IREDELL COUNTY HEALTH DEPARTMENT

IMPROVEMENT PERMIT / AUTHORIZATION TO CONSTRUCT / OPERATION PERMIT / EXISTING SYSTEM INSPECTION

PERMIT# 095624 PIN# 4723 23 3371 DATE 4/24/01

SUBDIVISION SPRING MEADOWS BLOCK / SECTION LOT 34 LOT AREA .97 Ac. SITE CLASS. PS DESIGN FLOW 360 GPD L.T.A.R. .30

AS BUILT SKETCH

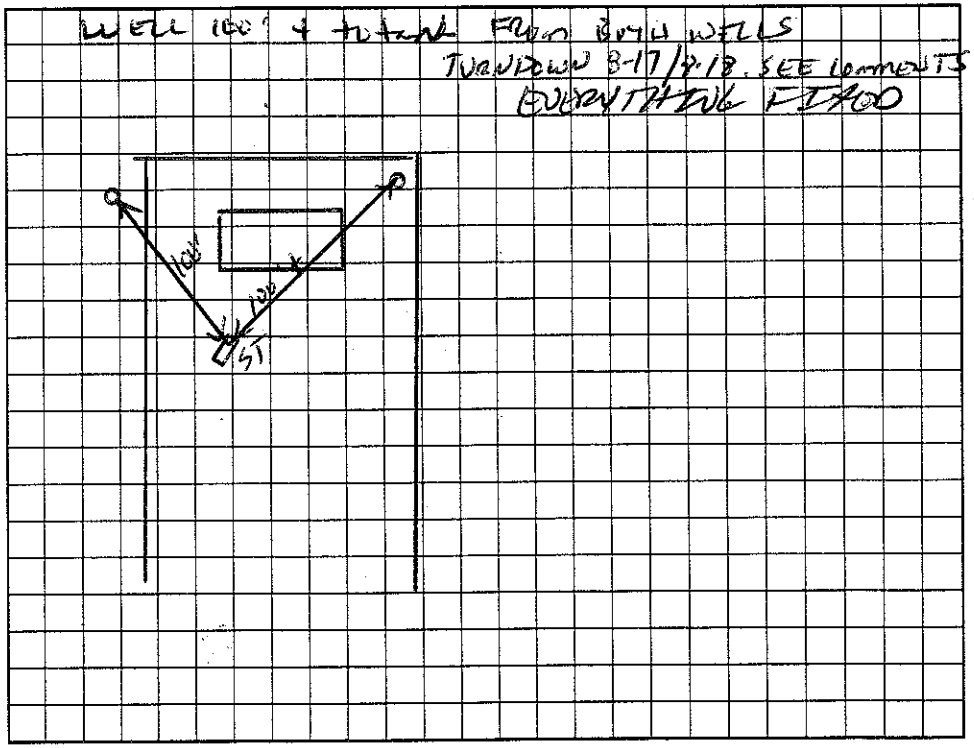
Comments/Conditions: (1) START 1st DRAINLINE APPROX. 70' FROM HOUSE (2) INSTALL DRAINLINES UNIFORM AND ON CONTOUR (3) NO CUTTING OR FILLING OVER DRAINFIELD/REPAIR AREAS (4) KEEP ALL DRAINS AWAY FROM DRAINFIELD/REPAIR AREAS

Comments/Conditions: POLYLOK FILTER & MARKER
✓ VENT WHEN COME BACK

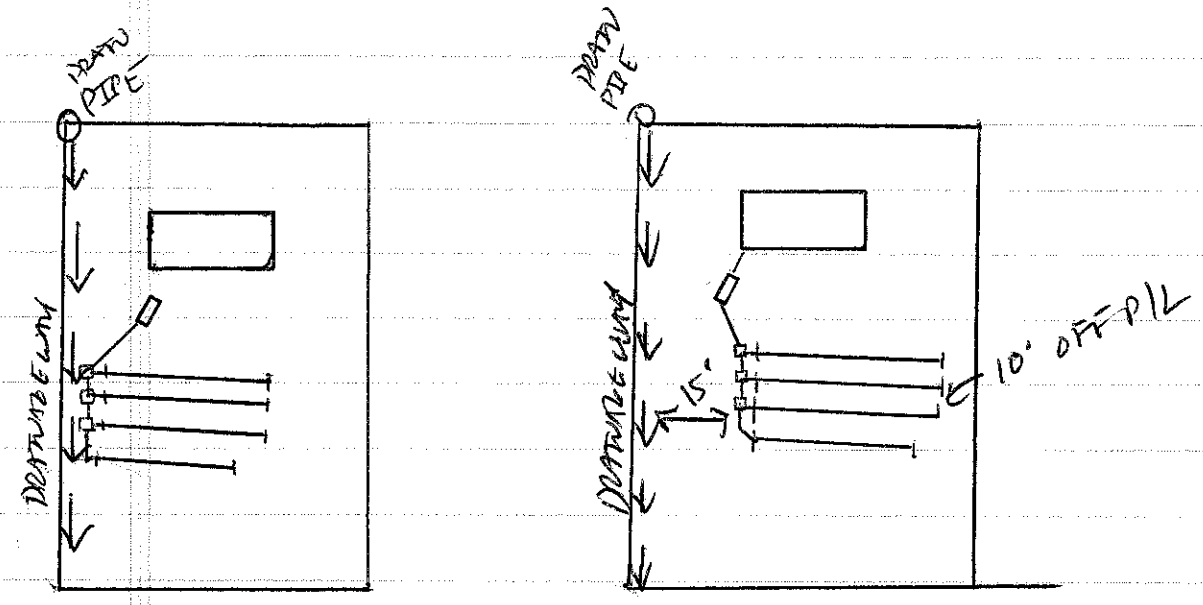
LINE 1	80'	3 1/2" FALL	⊗
LINE 2	80'	1 1/2" FALL	✓
LINE 3	80'	2 1/2 FALL	⊗
LINE 4	60'	3" FALL	⊗

LINES WERE ≈ 30' - 40' OFF P/L & BEGINNING IN MIDDLE OF DRAINAGE WAY. TURNDOWN & TOLD THEM TO SLIDE ENTIRE SYSTEM TOWARDS P/L & 15' OFF DRAINAGE WAY. ALSO LINES 1 | 3/4 HAD TO MUCH FALL
